16-ESQ-0128

TRANSFER OF OPERATIONAL RESPONSIBILITY OF THE 1301-N LIQUID WASTE DISPOSAL FACILITY, 1324-N SURFACE IMPOUNDMENT AND 1324-NA PERCOLATION POND, AND 1325-N LIQUID WASTE DISPOSAL FACILITY; SUBMITTAL OF ASSOCIATED HANFORD FACILITY RESOURCE CONSERVATION AND RECOVERY ACT (HF RCRA) PERMIT CLASS I PERMIT MODIFICATIONS

DOE and Ecology use permit change notices (PCNs) to help track and process Class 1 permit modifications. This modification package addresses the following PCNs:

Figure 1. HMAPS (WIDS and Wells) Download: 1324-N and 1324-NA

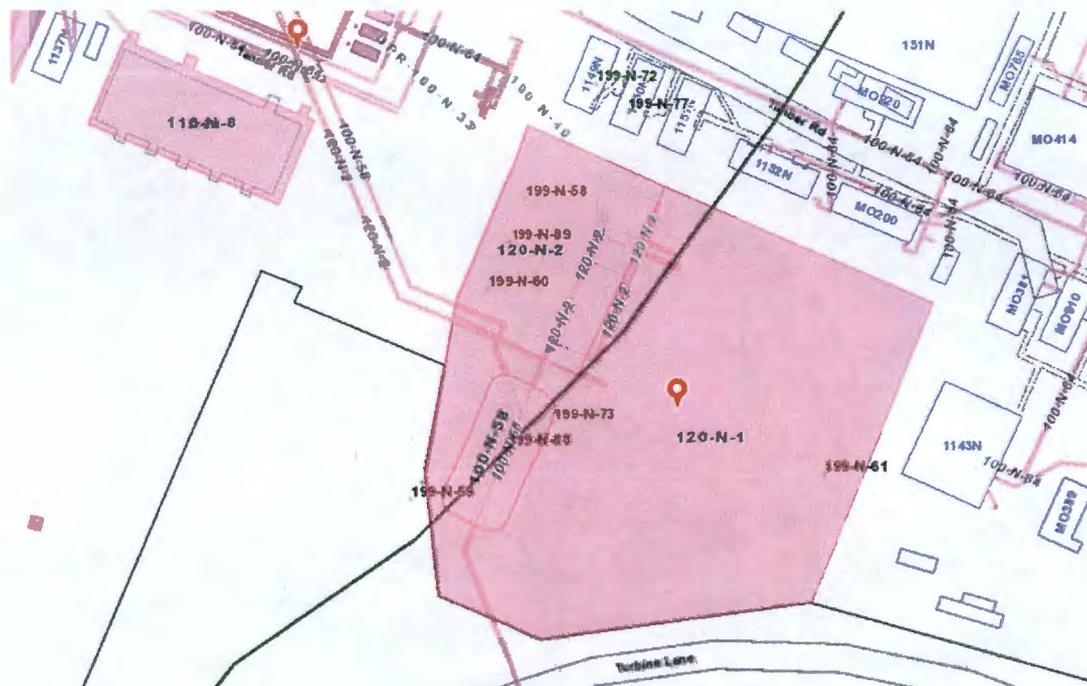
This document has been revised from Revision 4 to Revision 5 because of a change in the Co-Operator, which necessitated an addition to Section XI, Nature of Business. Figures 1 and 2 were added to show the ground contour as it existed on August 3, 2016.

Figure 3. HMAPS (WIDS and Wells) Download: 1324-N and 1324-NA (120-N-1 and 120-N-2)

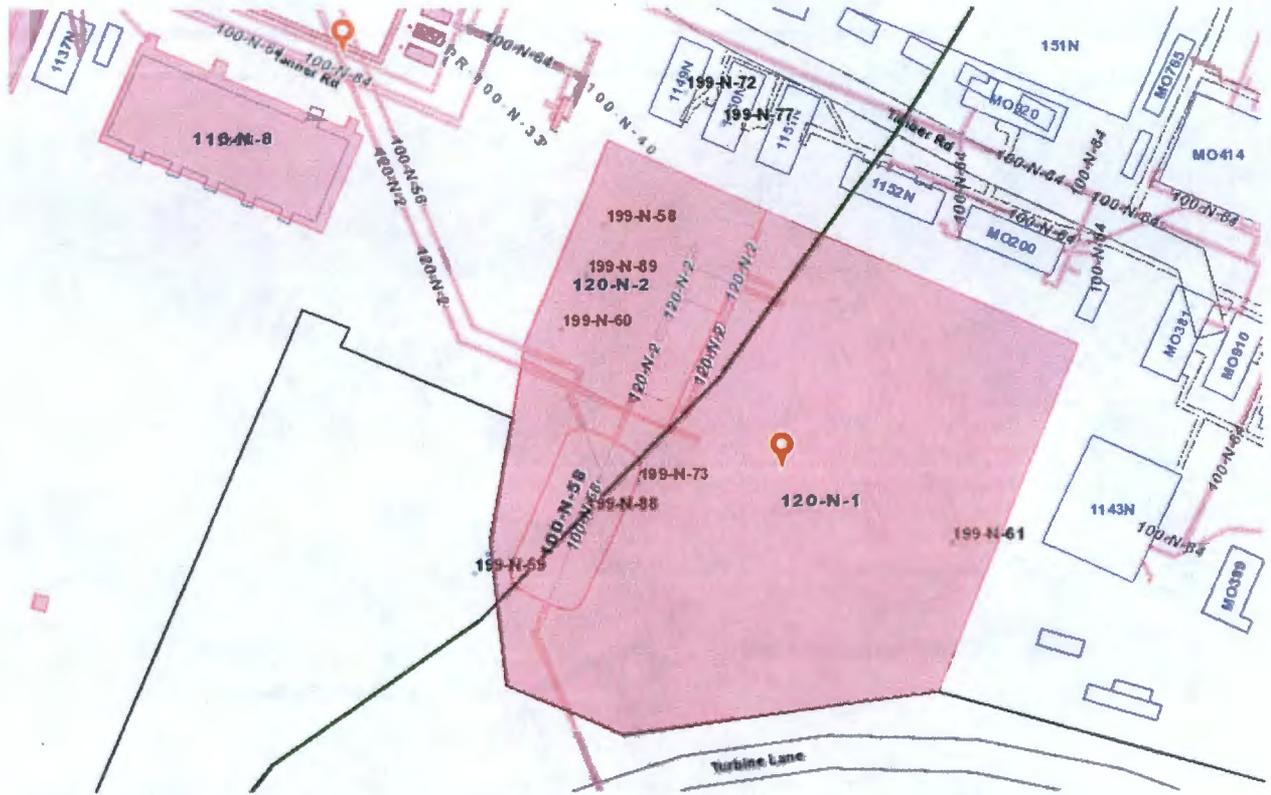
This document has been revised from Revision 4 to Revision 5 because of a change in the Co-Operator, which necessitated an addition to Section XI, Nature of Business. Figures 3 and 4 were added to show the ground contour as it existed on August 3, 2016.
